City of
Richmond

Report to Development Permit Panel

File: DP 22-023117

Re: **Application by Wayne Fougere for a Development Permit at
9511 Granville Avenue**

Section View of cantilevered slab over critical root zone of Tree #713

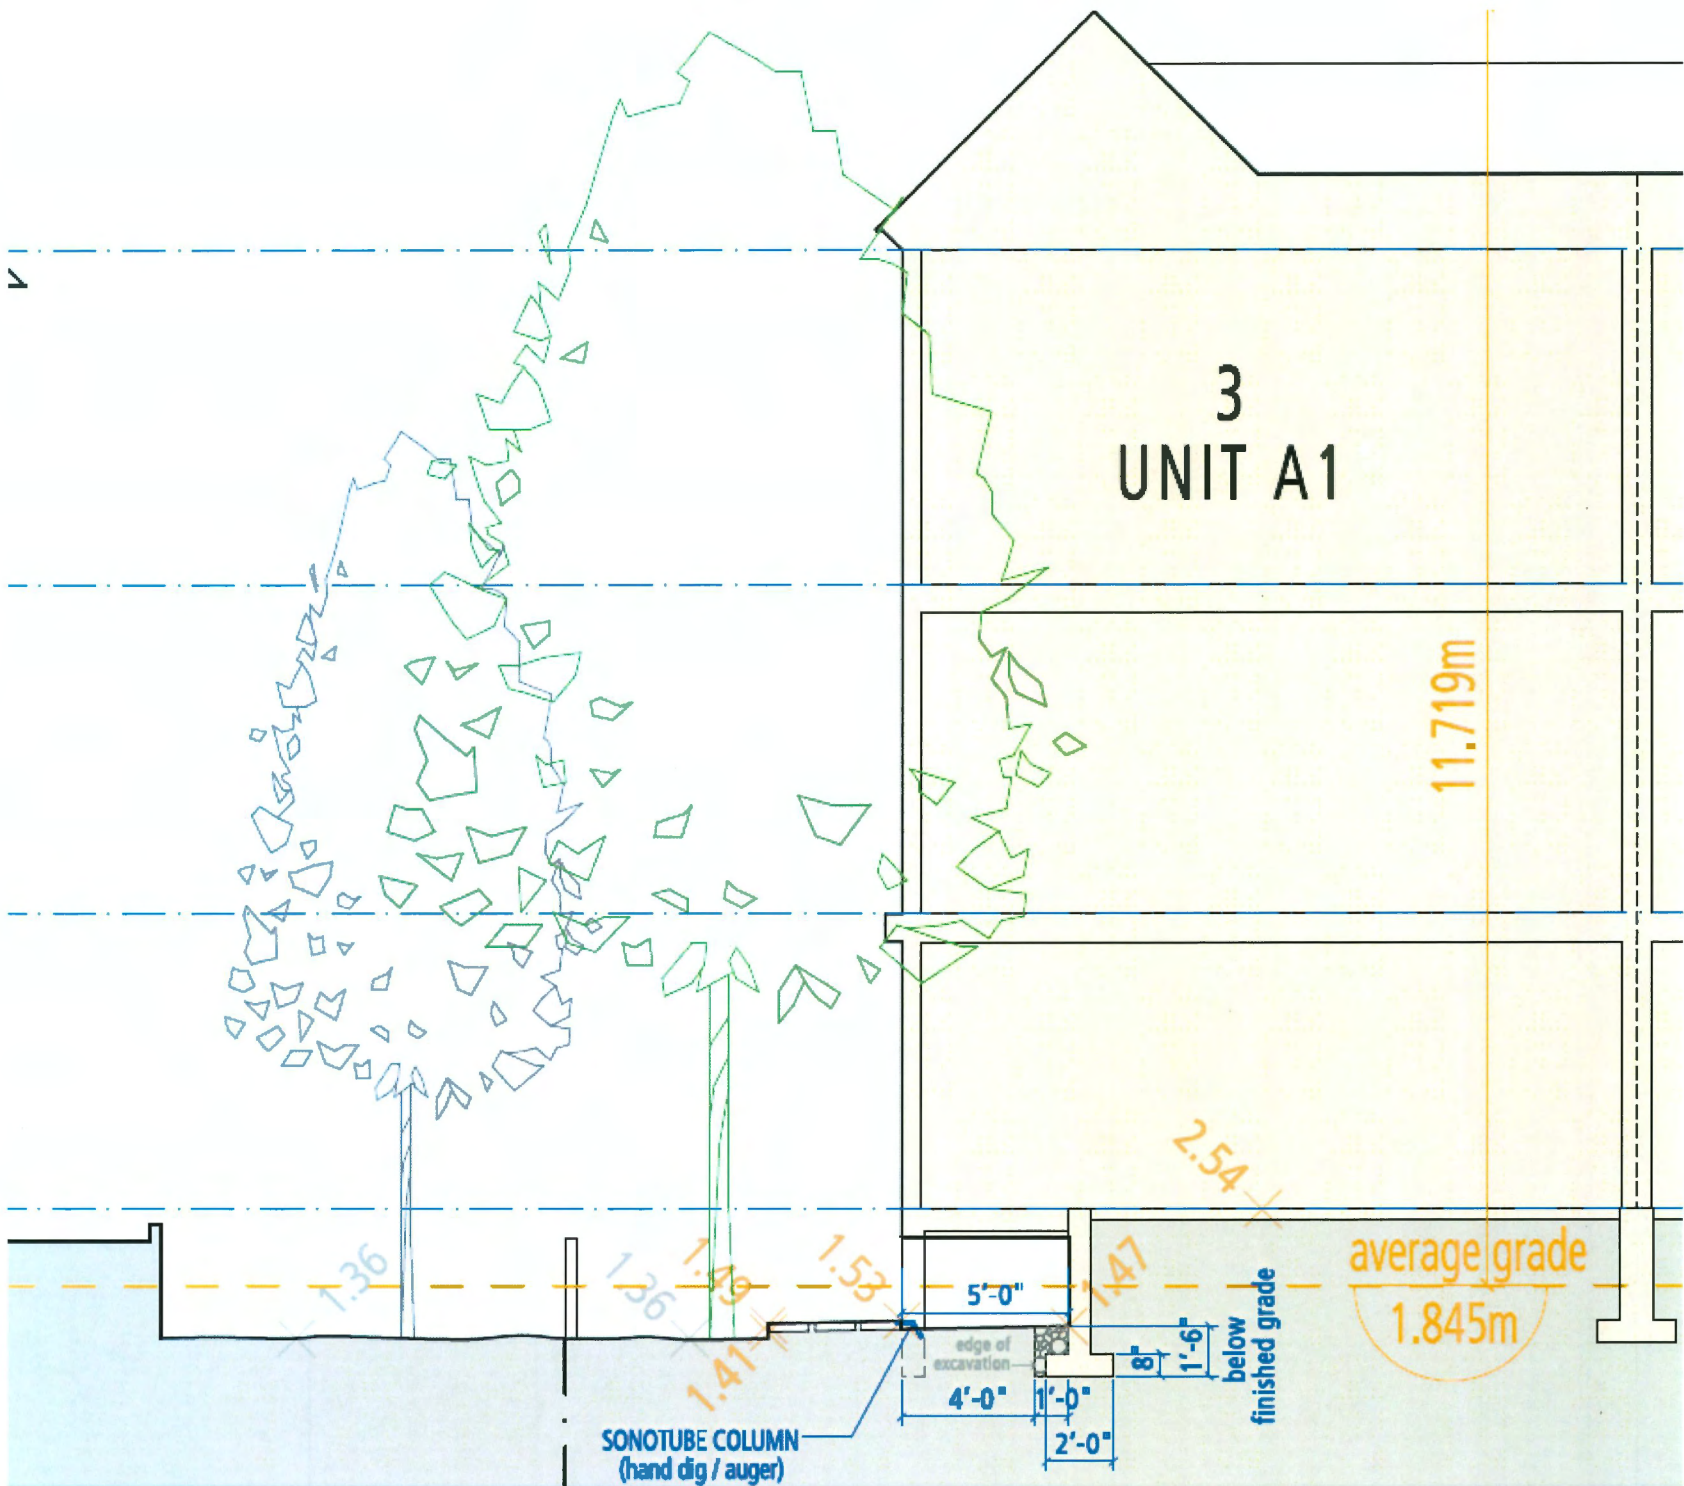
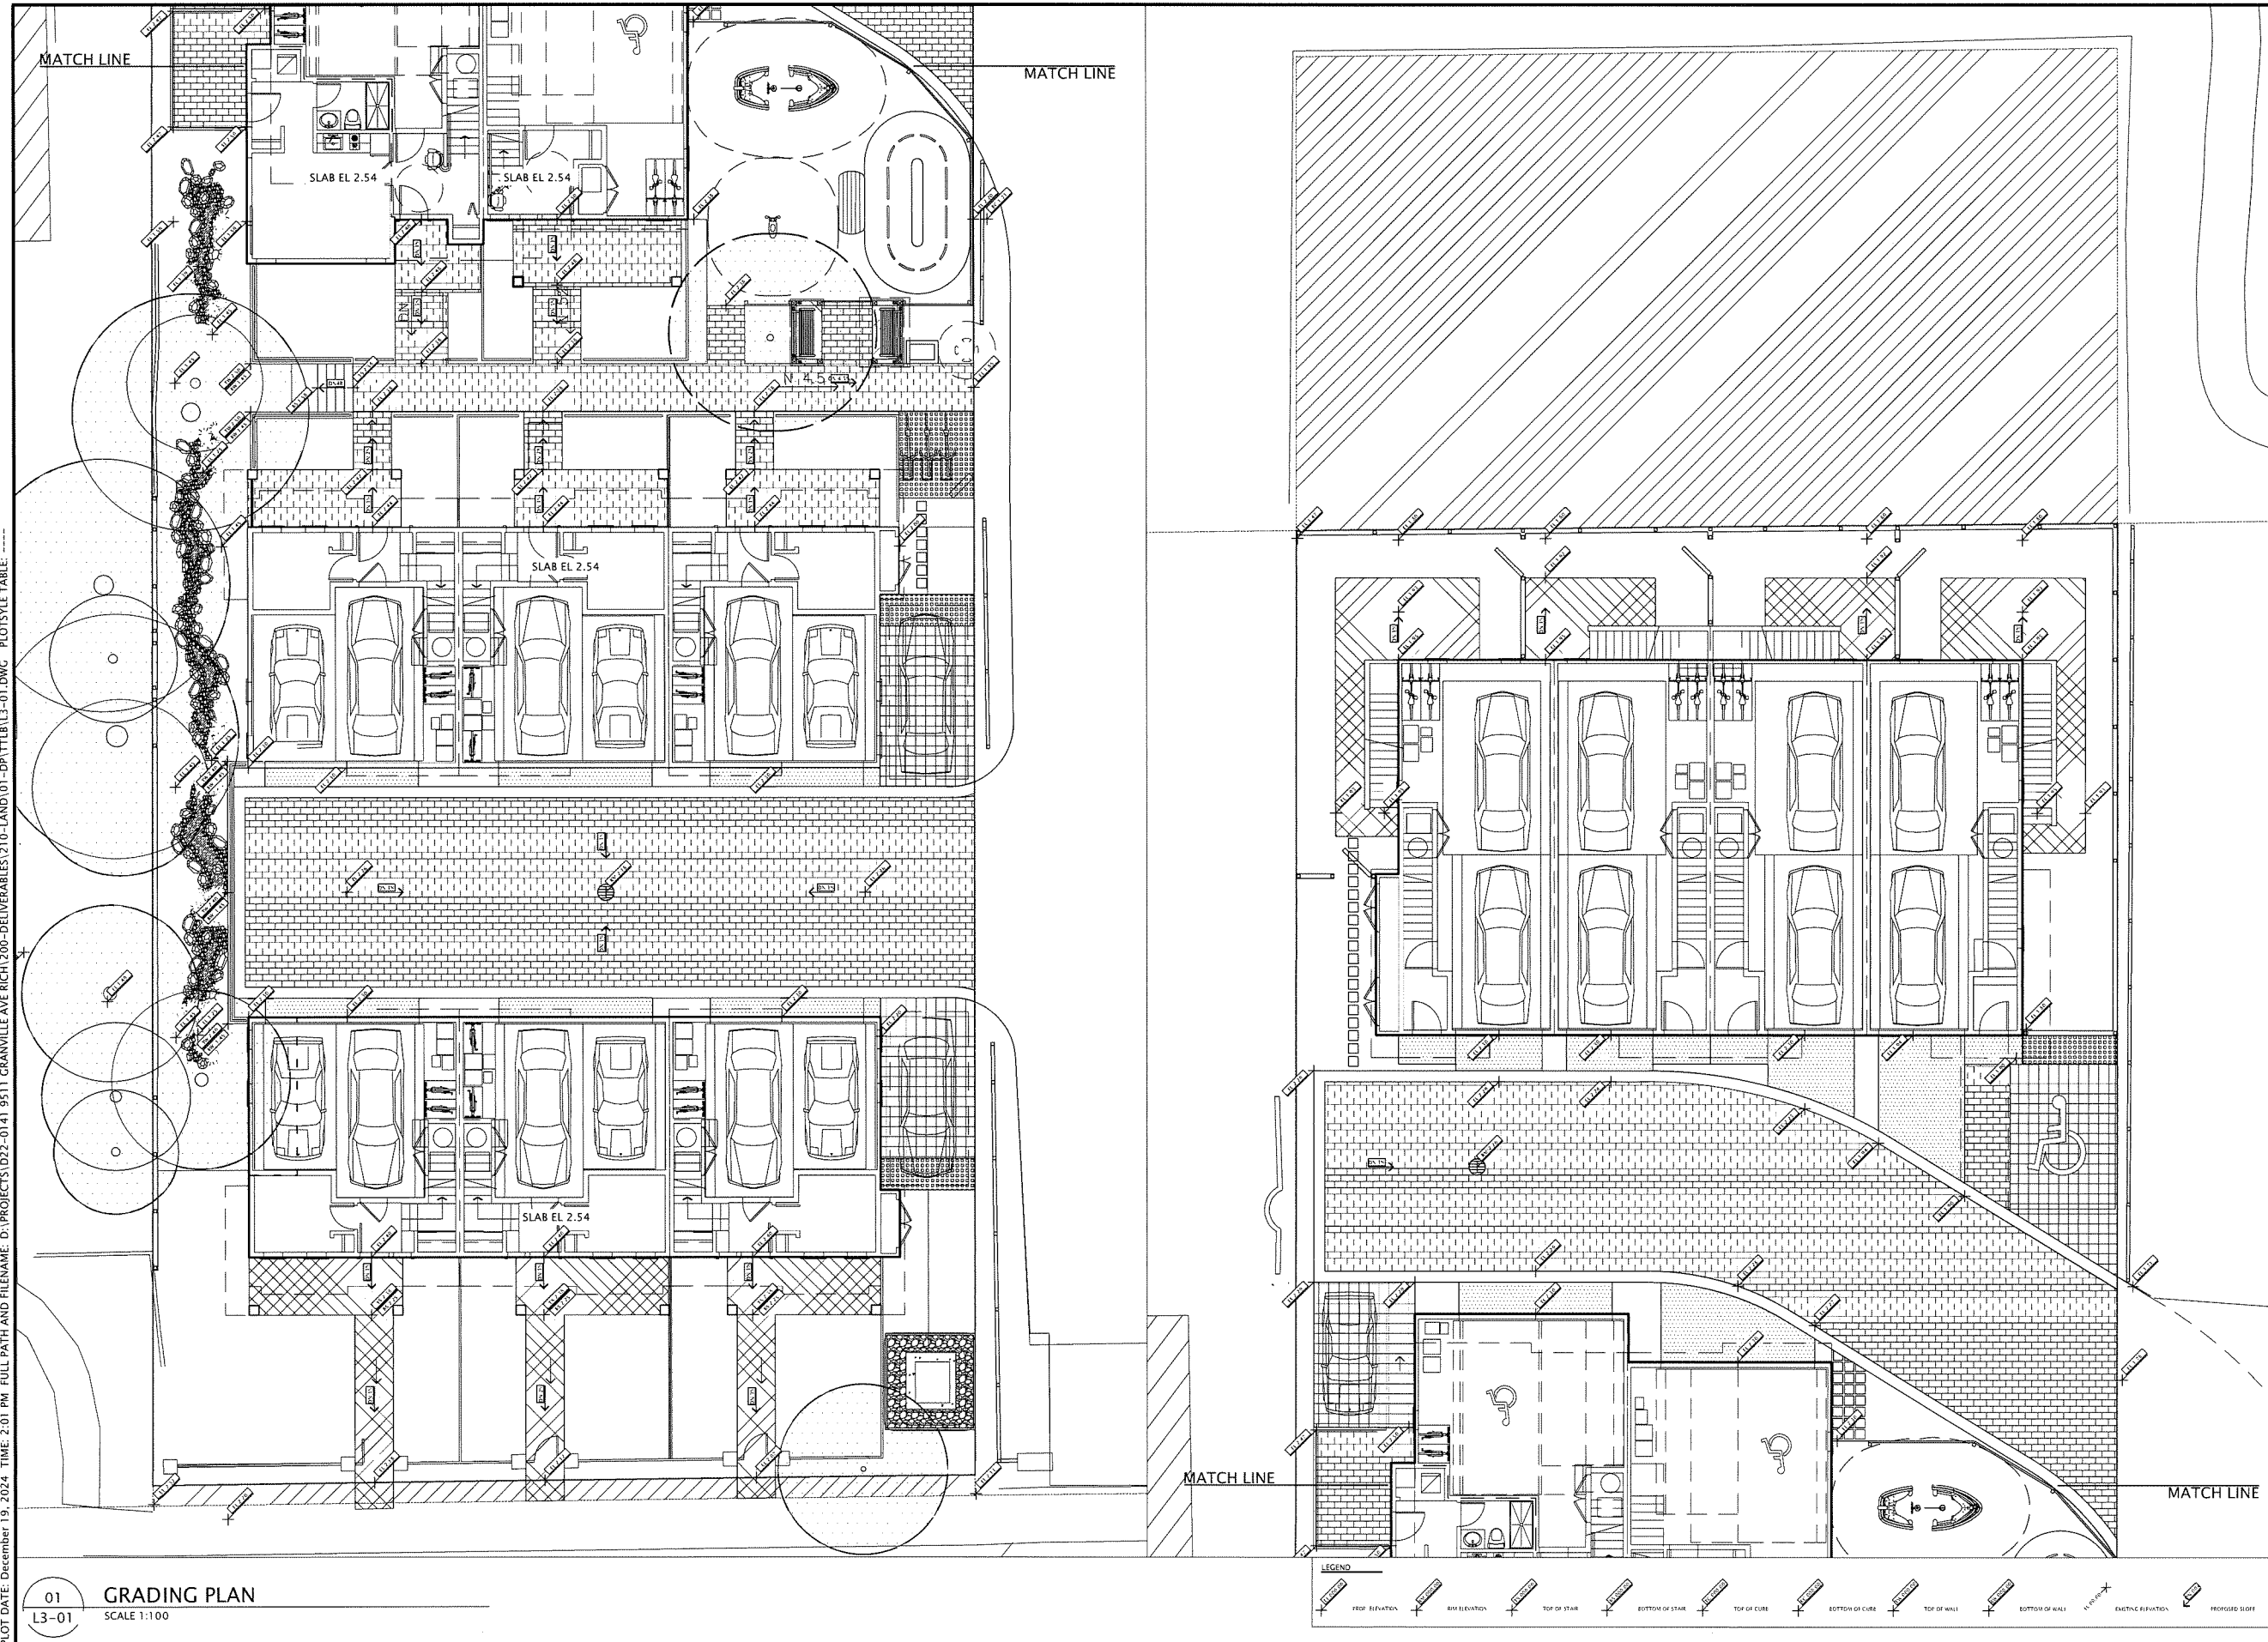
CANTILEVERED SLAB AREA
 To mitigate impact to the critical root zone of Tree #713, the building has been redesigned in this area to reduce excavation requirements for the outer foundation wall. Grading change will be required within the slab area but limited to 8 inches depth below existing grade.

FLOOR PLANS BUILDING 3

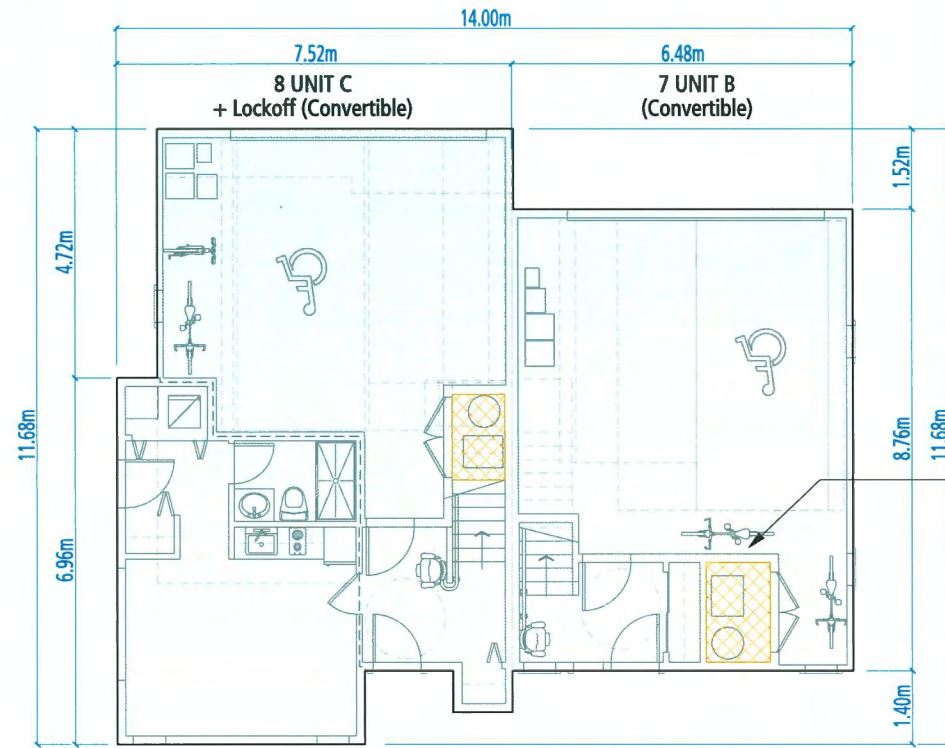
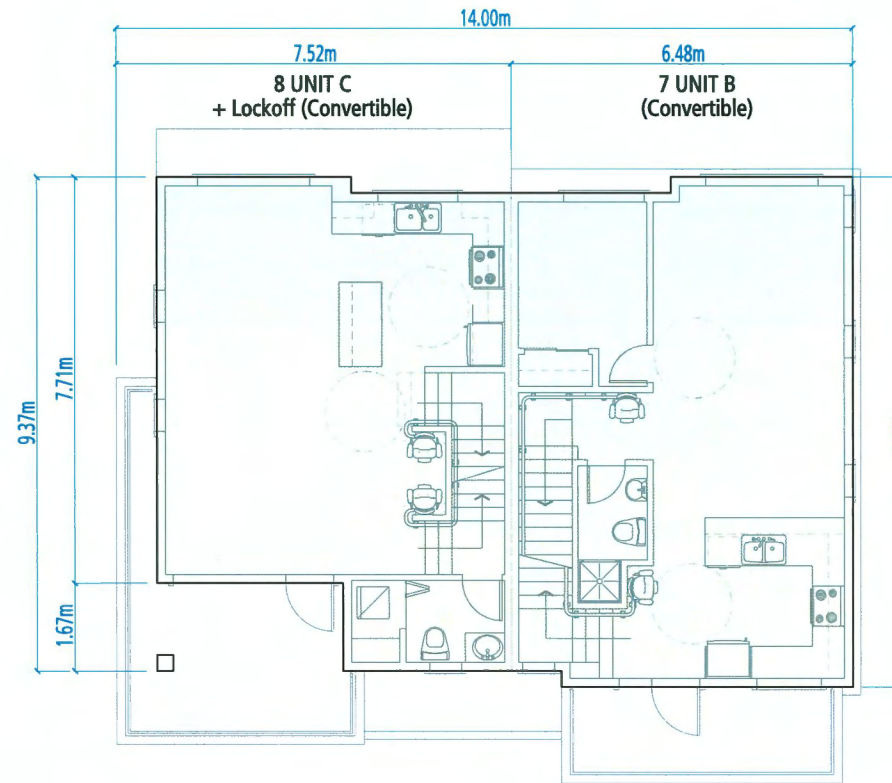
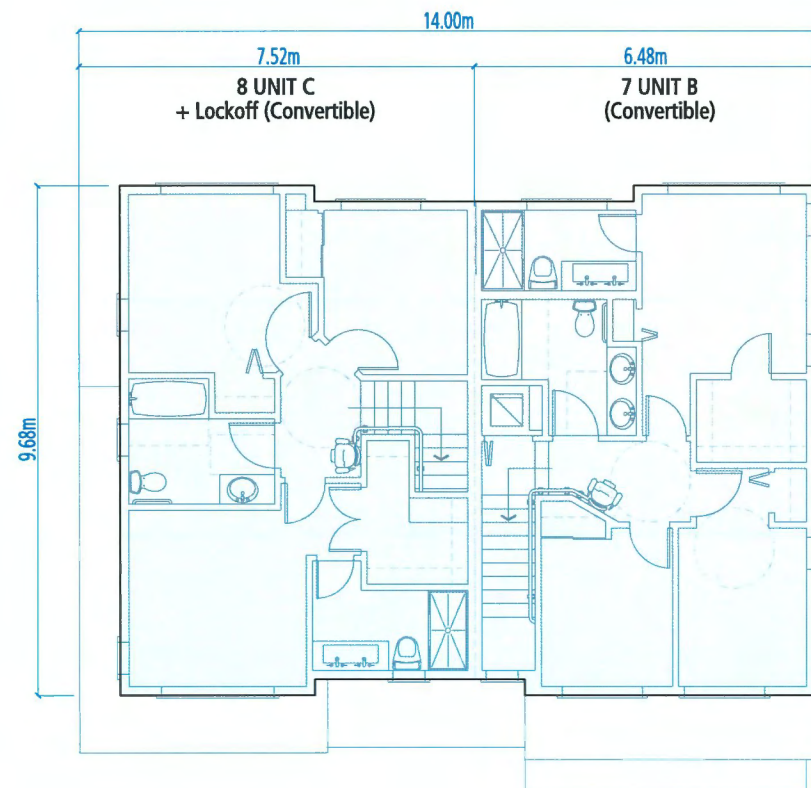
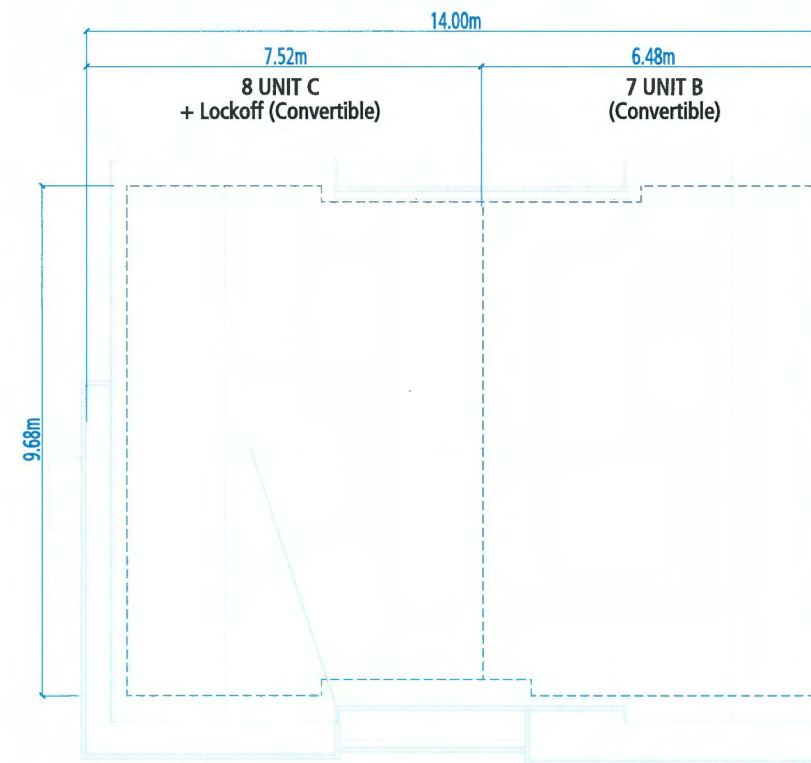
- consider installing landscape buffers to provide screening for the windows of the Building 3 unit adjacent to the children's play area; also look at different play equipment to tighten up the fall radius;
As the ground level windows adjacent to the playground open onto the garage of the unit, there should be no appreciable privacy issue for the residents. Fall radii are nominal and it is felt that the current configuration offers a good mix of play options and is complimentary to the neighbour's play area.

- consider adding a downspout or reveal at Building 3 north elevation between the two units to provide identity to each of the units in keeping with the Development Permit Guidelines.
Downspouts added to building 3 north and south elevations.
